Khmelnitsky NPP

Construction of Units 3, 4

Expert Statement to the Information and Analytical Survey
of the Feasibility Study and the EIA Report of the FS

REPORT
REP-0441

Figure 1: VVER Technology Evolution:

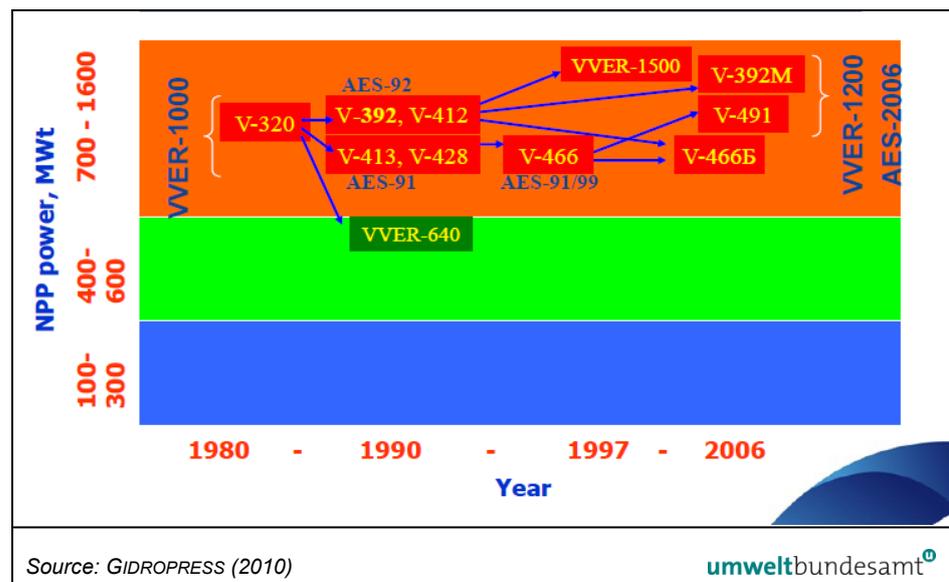
The main reactor design being deployed until now has been the reactor type V-320 version of the WWER-1000 pressurized water reactor. It's basic design life time is 30-years – the design dates from the 1980s. A later version of the V-320 aimed for export is the reactor type V-392, with enhanced safety and seismic features. Advanced versions of this WWER-1000 with western instrument and control systems have been built at Tianwan (AES-91) in China and are being built at Kudankulam in India (AES-92). The AES-91 was bid for Finland in 2002. The AES-92 was bid for Sanmen and Yangjiang in China in 2005 and was accepted for Belene in Bulgaria in 2006. AES-91 and AES-92 have a 40-year design life, major components of the two designs are the same except for a slightly taller pressure vessel in AES-91, but cooling and safety systems differ. The AES-92 has greater passive safety features (WNA 2012).

The important difference between the chosen reactor type V-392B and the also considered reactor type V-466 for completion of the KNPP 3 & 4 is the so-called **core catcher⁸ – V-392B does not have a core catcher**. If this corium localization device is functioning as planned, it would have the potential to reduce the probability of large releases in case of a severe accident. However, there is no

Figure 2: Deposition of cesium-137 from a hypothetical BDBA in KNPP-2.

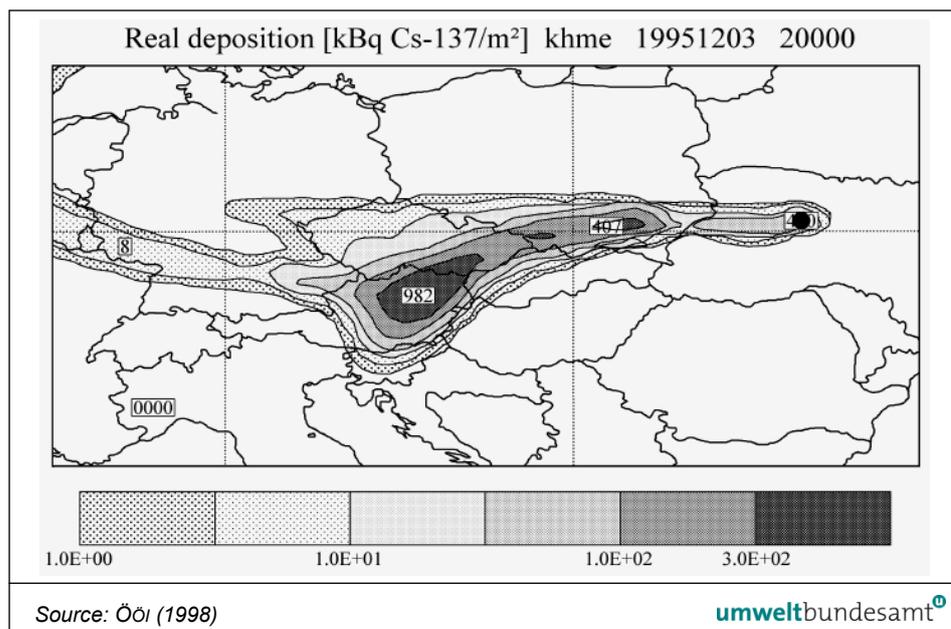
The **results** of the presented calculation indicate that there is the possibility that an accident at the KNPP would contaminate not only regions in Ukraine, but also several regions in Europe, as it happened in May 1986 after the Chernobyl accident. The contamination maxima could be even higher as 1986. For the Eastern part of Austria, the calculation resulted in values up to approx. 1,000 kBq/m² contamination with cesium-137 (which is about 5 times the highest values measured in Austria in 1986).

Figure 3 Average deposition of Cs-137 after a hypothetical BDBA in KNPP-3

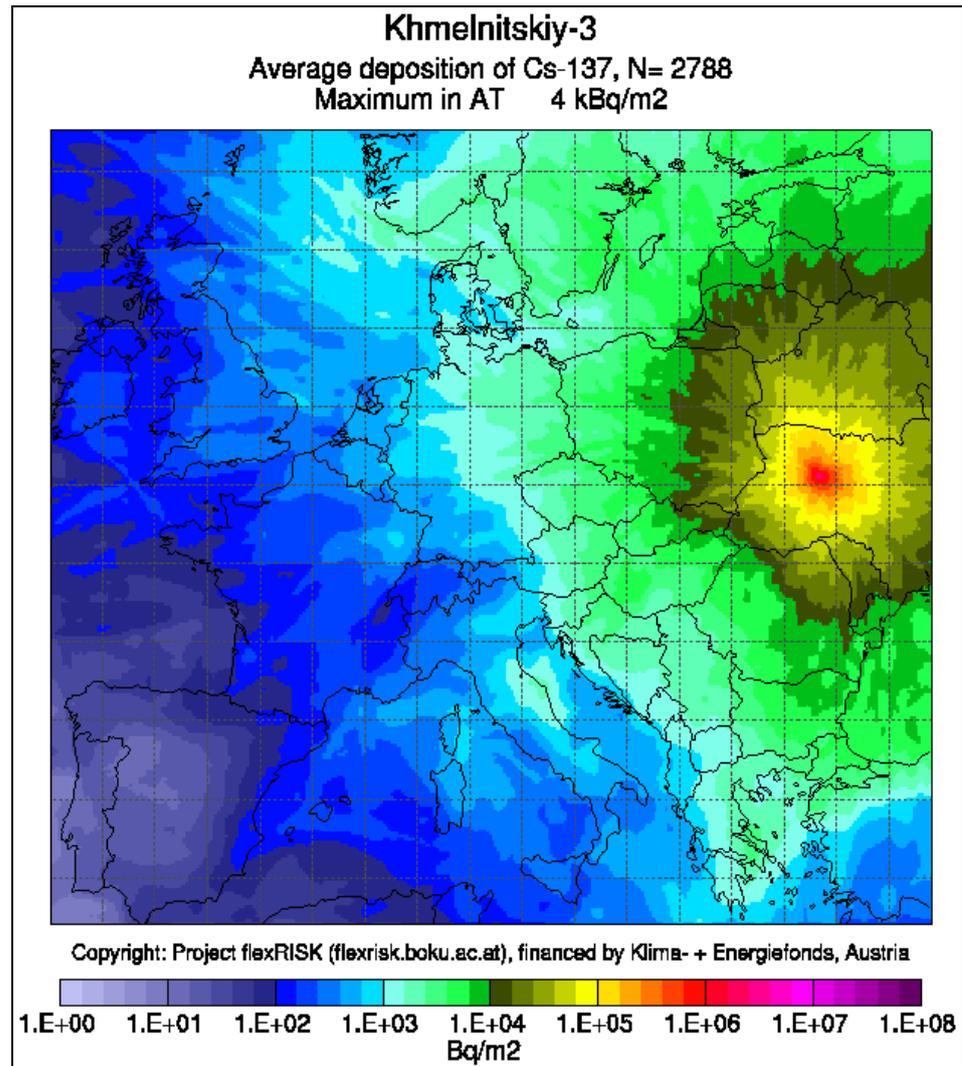
Figure 3 (page 50) illustrates the average deposition of cesium-137 after a severe accident at KNPP-3.

An accident could result in a considerable contamination of the Austrian territory; the average deposition of Cs-137 in the simulation being between 500–5000 Bq/m². Most parts of Austria show depositions of 800 Bq/m² or more.

If the contamination of ground beyond a certain threshold can be expected, a set of agricultural intervention measures is triggered (FLEXRISK 2013). The measures include earlier harvesting, closing of greenhouses and covering of plants, putting livestock in stables etc. Austrian and German authorities defined a threshold for cesium-137 ground deposition of 650 Bq/m² (SKKM 2010; SSK 2008). As within the simulation the average ground depositions of most areas are higher than this threshold, Austria would be most likely affected from a severe accident at KNPP-3,4.
